STAFF REPORT
KETCHUM PLANNING AND ZONING COMMISSION
SPECIAL MEETING OF MAY 24, 2022

- PROJECT:** 940 Leadville Ave
- APPLICATION TYPE:** Conditional Use Permit (File No. P22-010)
Design Review (File No. P21-011)
- APPLICANT:** Amy Martin (applicant Conditional Use Permit)
Michael Blash (architect - Design Review)
Alex Nelson, Alpine Enterprises (Engineer - Design Review)

- PROPERTY OWNER:** Amy Martin
- REQUEST:** Conditional Use Permit application to establish a work/live unit in the LI-1 district, and a Design Review application for the partial demolition of the existing structure, construction of a 1,352 square foot addition to the north end of the existing structure, and waiver of sidewalk construction requirements.

SITE PLAN

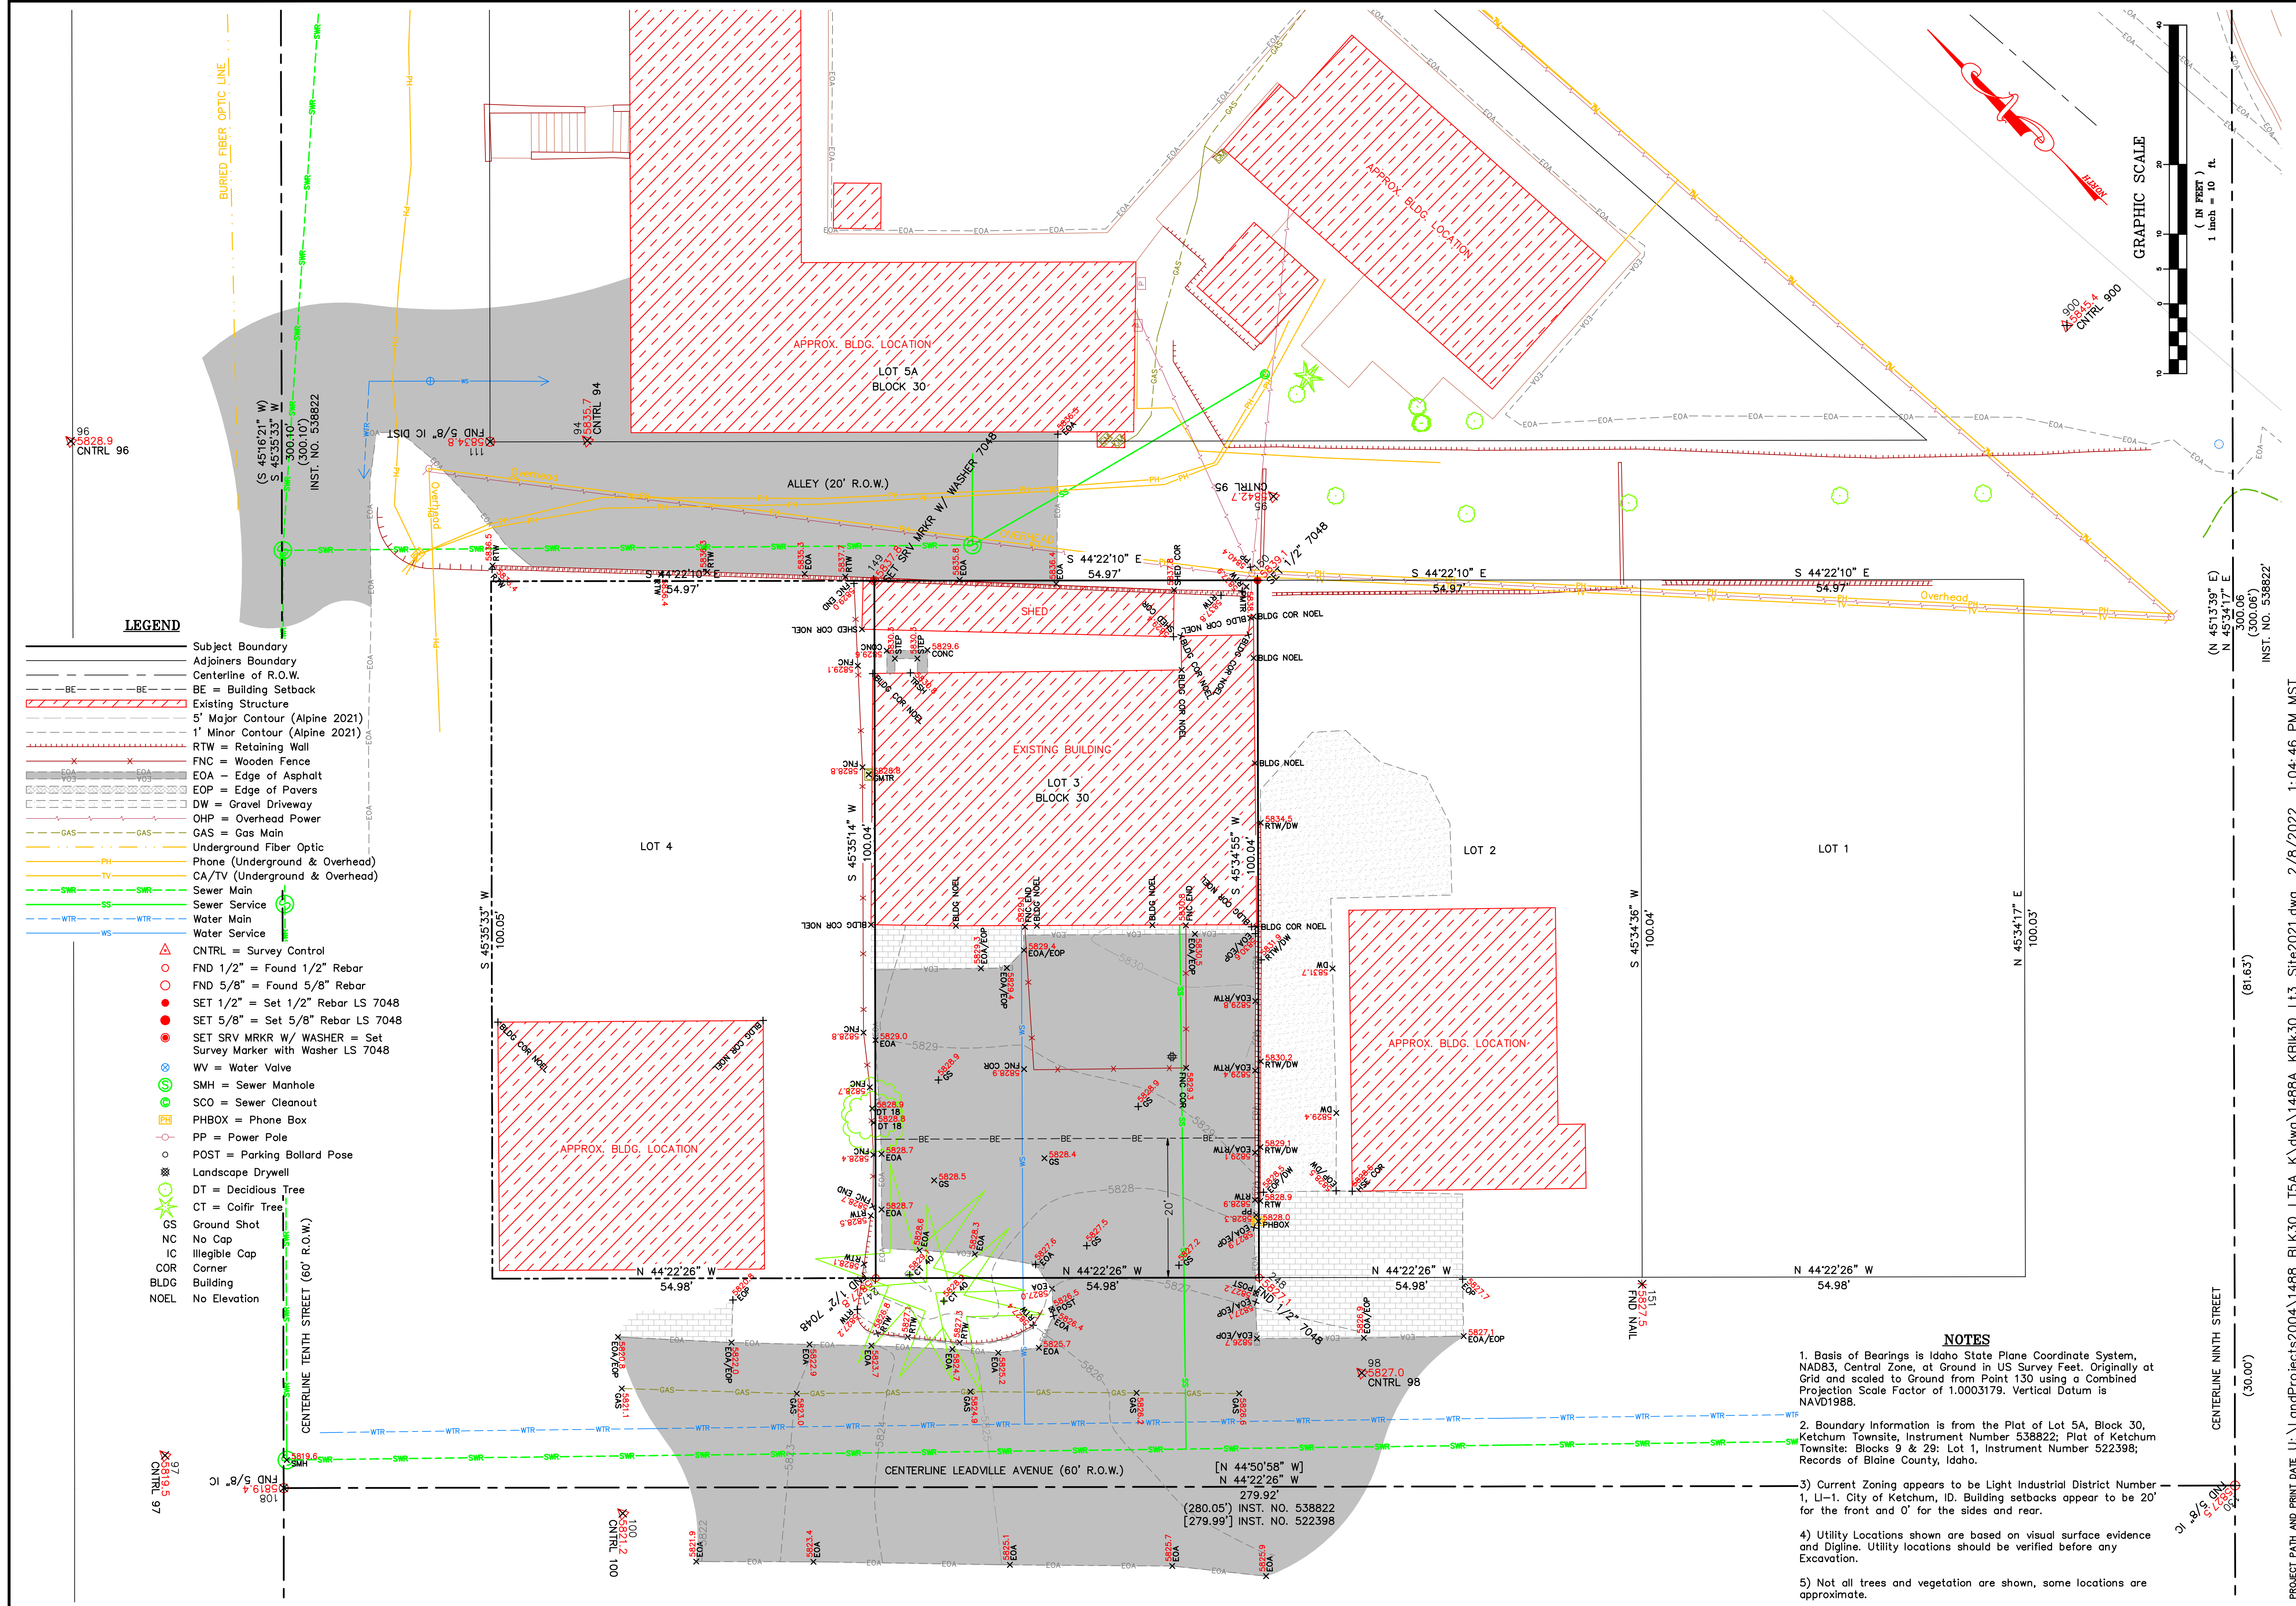
17.132 – Dark Skies	Conformance
<i>Compliance with Section 17.132 – Dark Skies.</i>	YES
<p>Finding: As shown on Sheet A3, the project proposes minimal exterior lighting for the project that does not trespass onto adjacent properties. The two fixtures proposed are both dark sky compliant. Final review of light fixtures for compliance with the city’s dark sky ordinance will be completed at the time of building permit application and review. There is one existing fixture that will be removed with the demolition of the project and replaced with the light fixtures proposed in the project plans.</p>

As shown on Sheet A3, the work unit is access via the garage door and an entry door in the northern portion of the proposed project. This is the prominent access to the work unit. The residential unit is accessed through a separate door on the south end of the building which accesses the live unit specifically.

NORTH ELEVATION

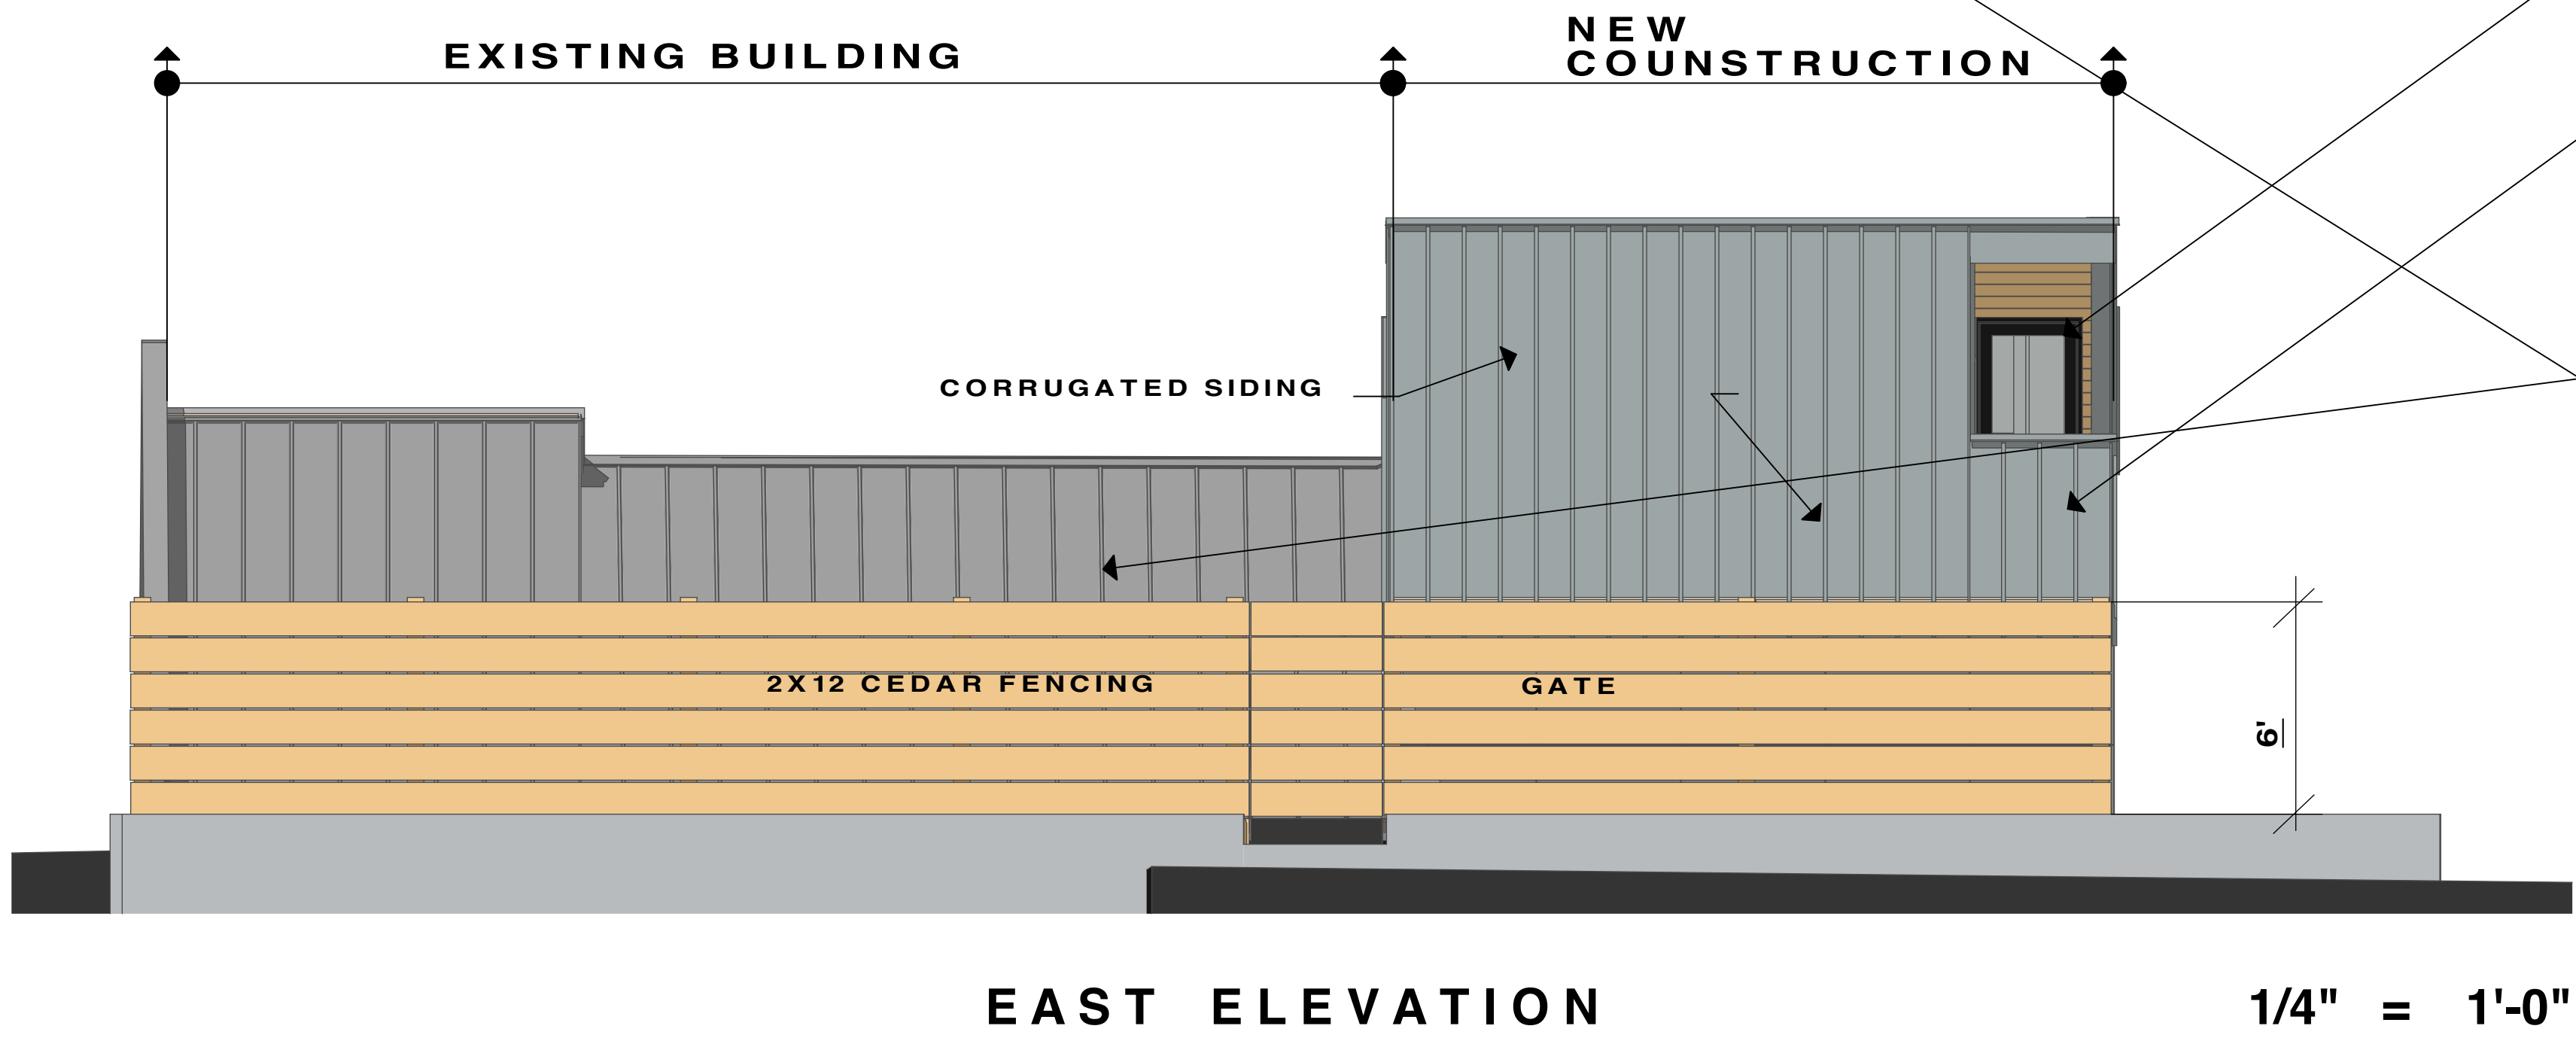
The initial application submittal included one consistent material along the north elevation of the proposed project. Staff provided feedback to the applicant that a variety of materials should be considered as this portion of the project is completely visible from the street due to site topography and height of adjacent buildings to the north. The applicant revised the project materials to introduce softer colors and more variation of patterns. The KMC does not provide specific direction for projects in the light industrial district, which arguably do not necessitate the same high level of finishings as buildings in the community core or tourist districts. Staff believes the proposed materials mimic the materials used on more recently constructed buildings within the light industrial district.
